NOISE TECHNICAL NOTE

CLIENT:	Knowsley Borough Council
PROJECT:	Halewood LUF
SUBJECT:	Response to Environmental Health Comments 17 th March 2025
JOB No.:	ST21181
DATE:	31 st July 2025
PREPARED BY:	Neil Fletcher - MIOA
APPROVED BY:	Jack Rostron - MIOA

2 RESPONSE TO ENVIRONMENTAL HEALTH COMMENTS

Figure 1: Noise Contour Plot – All Sources

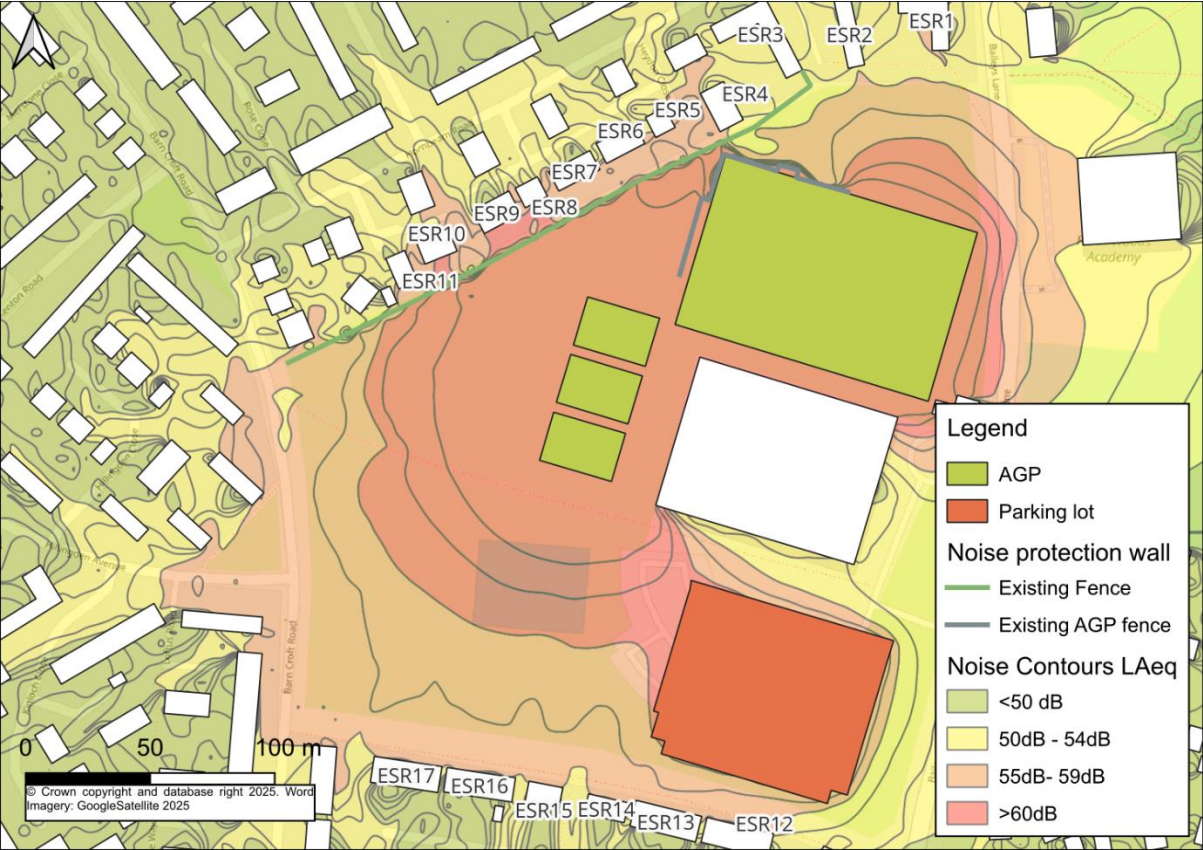
An assessment is required for open windows, it can not be assumed that if the level exceeds 48dB $L_{Aeq, T}$ that residents will have their windows closed. Most of the houses surrounding the centre will not have any internal ventilation (trickle vents etc) due to the age of the development and windows / patio doors have been observed to be open.

A worst-case hour assessment is presented below which includes the existing noise of the 11 a-side pitch in use, the 3 proposed AGP pitches with the same noise level and the proposed re-configured car park. Table 1 presents the results of the scenario described above with the existing 3.5m acoustic barrier in situ.

As shown above, internal noise levels at the nearest ESRs with windows closed are predicted to be below the 35dB noise guideline level for daytime periods. However, with windows open, assuming a 15dB reduction for a partially open window the predicted noise levels exceed the internal guideline criterion.

The noise contour plot is presented in Figure 1 below.
